REPORT OF THE CONSULTATION RESPONSES TO THE CAMP DOLENT DRAFT DEVELOPMENT FRAMEWORK

A Draft Development Framework was prepared by the Planning Service for a potential residential development at Camp Dolent, Tertre Lane in the parish of Vale.

Camp Dolent on the 1787 Duke of Richmond map, with the modern boundary shown in red. The 1787 map is slightly inaccurate, hence the disparity in location.

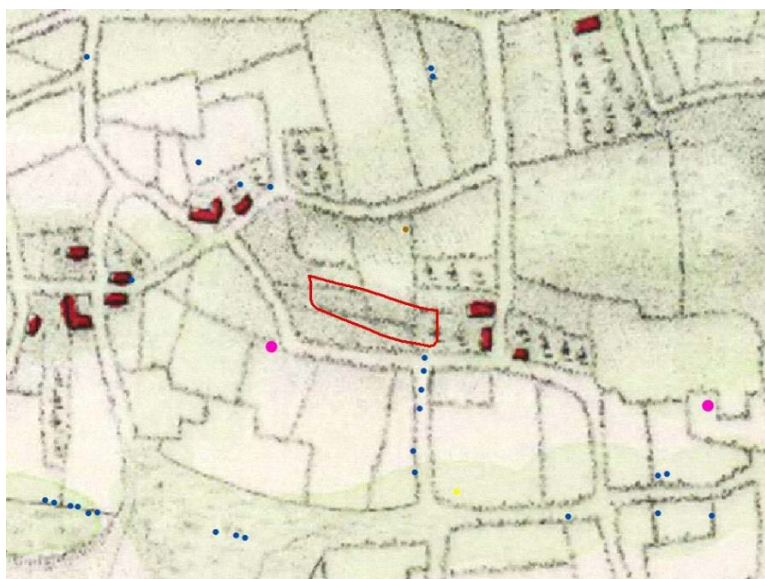
The field can be identified on the Duke of Richmond map of 1787; its present boundaries are unchanged (see image below). There is no known archaeology on the site, although there are records of two prehistoric stone axes found relatively nearby (represented by pink dots on the image).

In view of the lack of known archaeology on the site it would be useful if a resistivity survey could be carried out prior to development, which in turn might reveal features which could be targeted with archaeological test-pits. Resistivity survey can now be carried out by our department, utilizing equipment belonging to La Société Guernesiaise. Surveying this field would be a quick and convenient method of assessing its archaeological potential, prior to digging test-pits which necessarily take more time and effort.

Although there is no known archaeology on the site, due to the recording of two prehistoric finds relatively nearby it is agreed that providing access to the site to enable its investigation with a resistivity survey prior to the development of the site should be encouraged.

'Due to the recording of two prehistoric finds relatively nearby, it is desirable that access be granted to the States Archaeologist, Culture & Heritage Service, to undertake a resistivity survey prior to development, which in turn might reveal features which could be targeted with archaeological test-pits'.
